Assessment of the Anticipated Impacts  
to the Lake Erie Shoreline  
From the Construction of a Marina  
at Beachwood Villas in Erie County, Ohio

*U.S. Army Corps of Engineers, Buffalo District*

*March 1987*

APPLICATION BY:  
 BEACHWOOD SHORES CORP  
 86-875-11  
 SHEET 2 OF 9

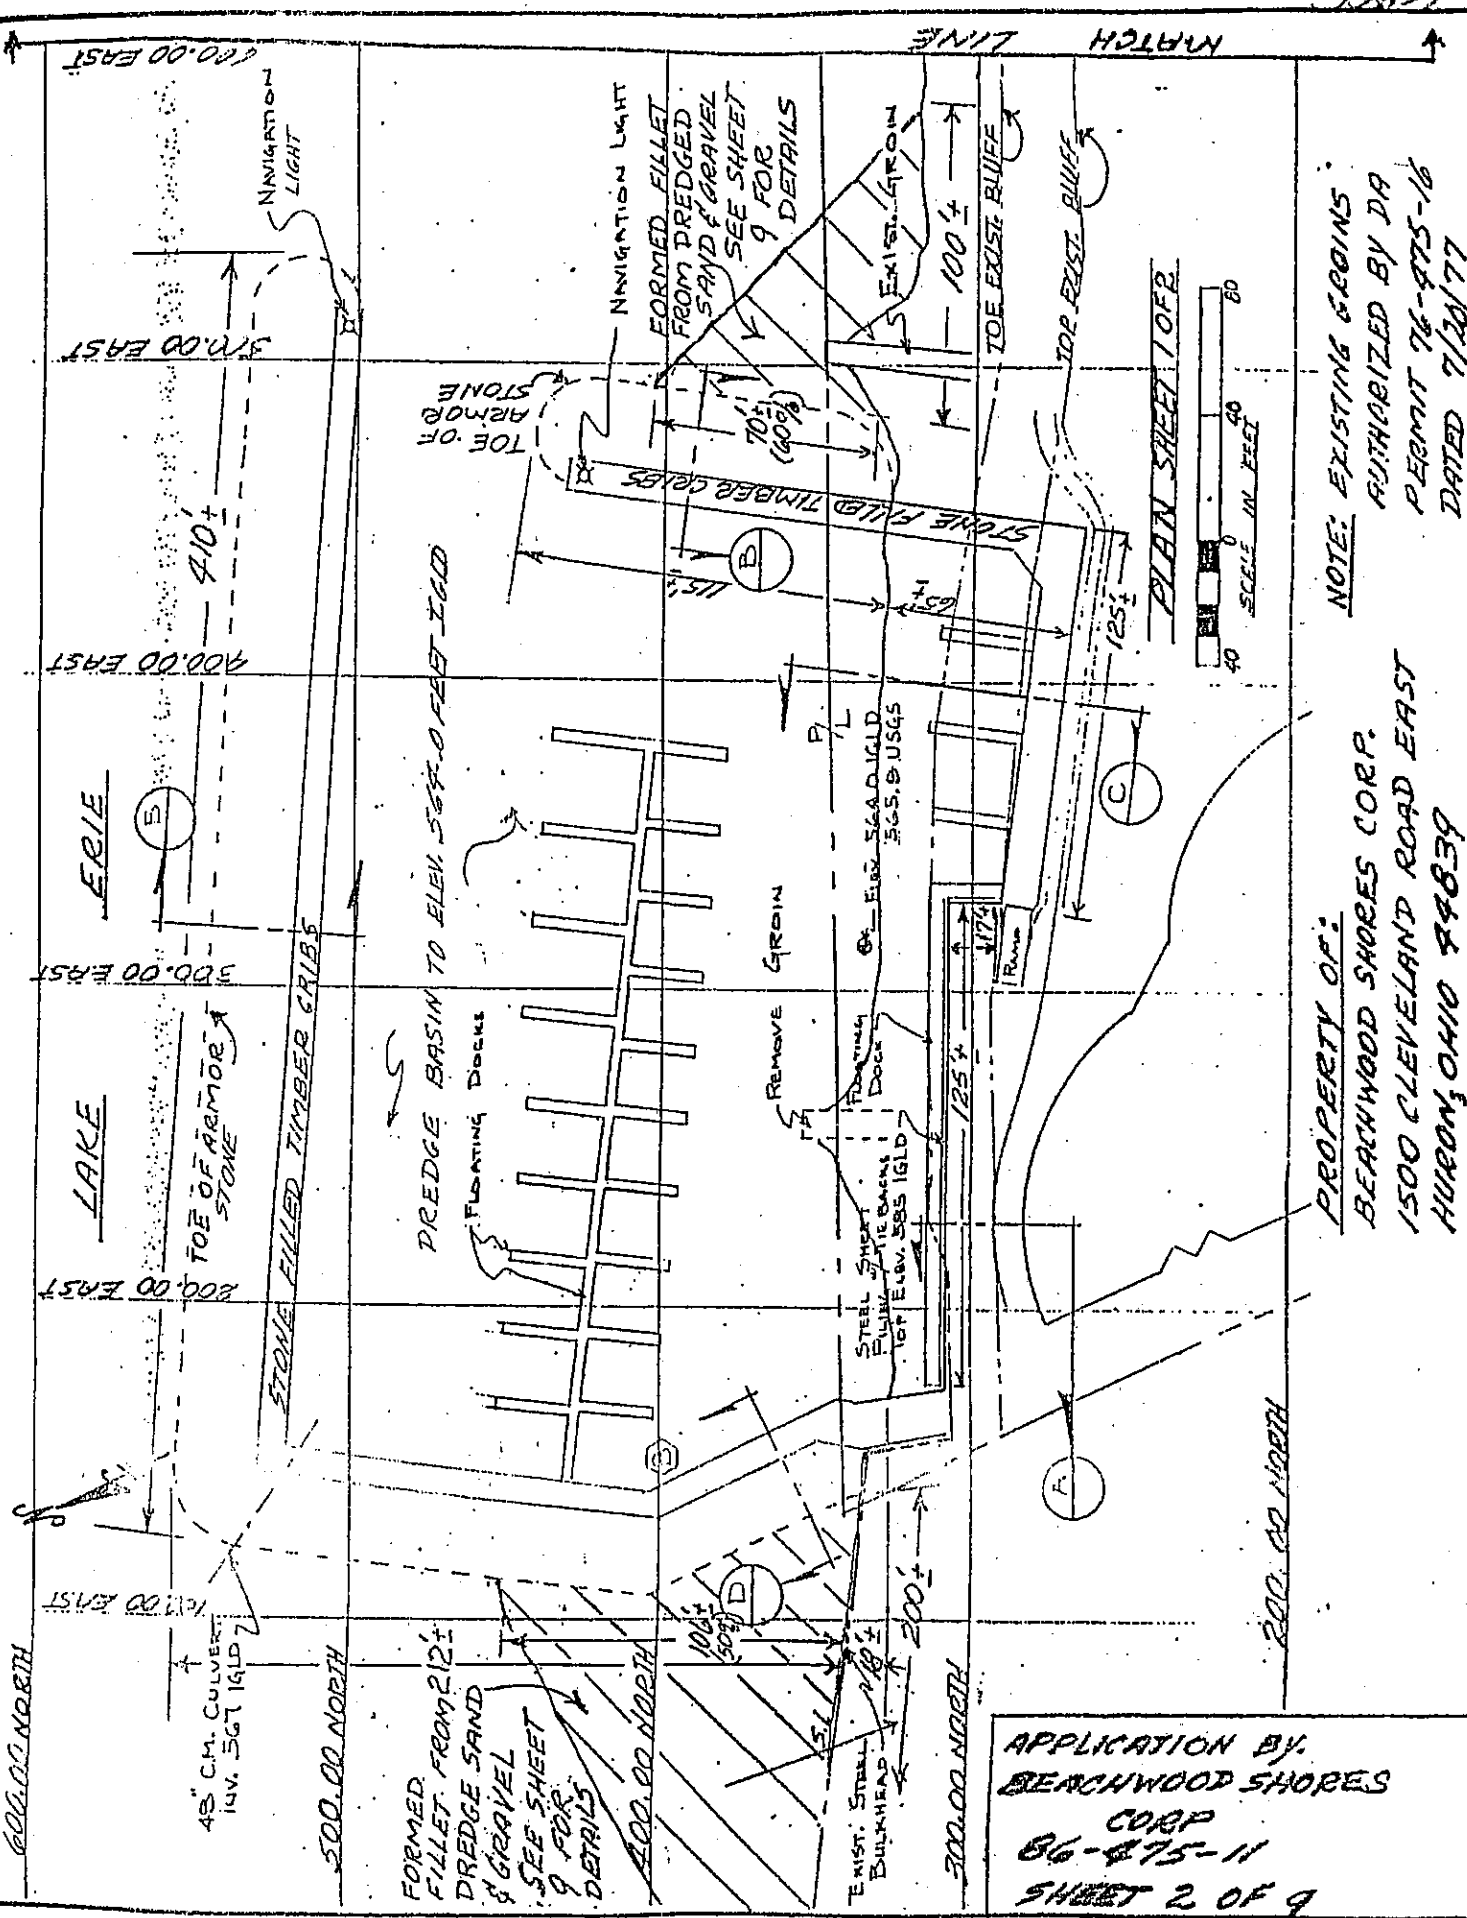
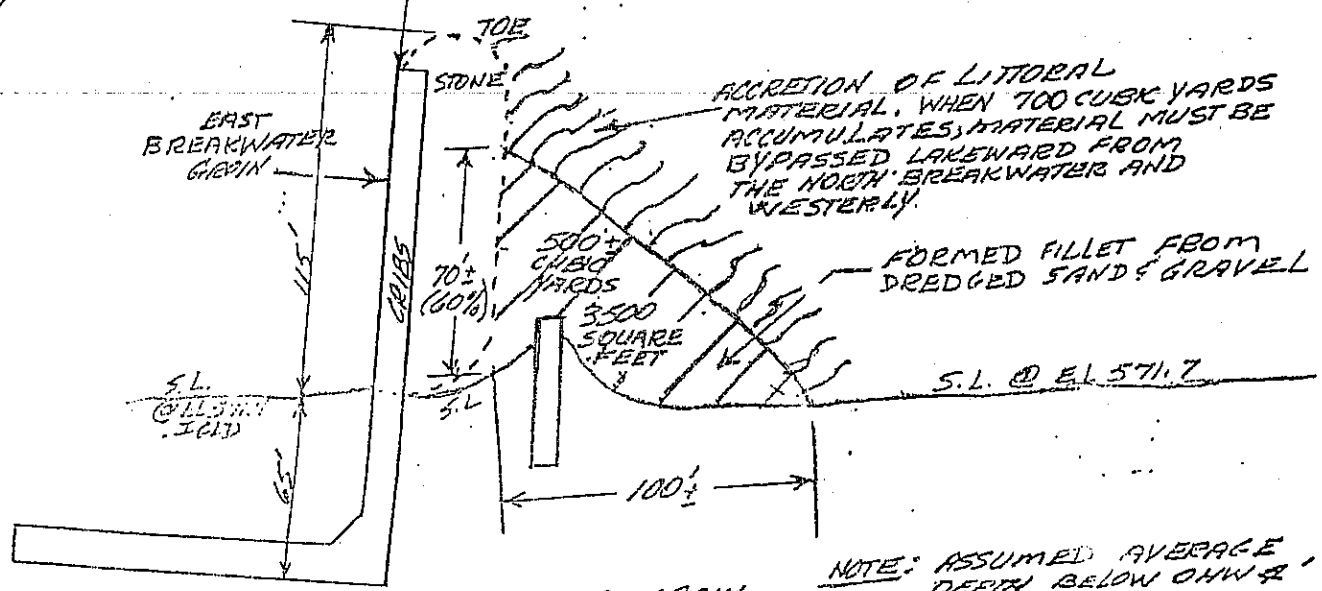
7. The configuration of the sand fillets to be formed from dredged sand and gravel (sheets 2 and 9 of 9) would probably change significantly from that shown. Measurements of beaches trapped by shore-normal structures at the worksite from 1980 and 1986 aerial photography shows that the width of the beach on the updrift side of the structures typically is
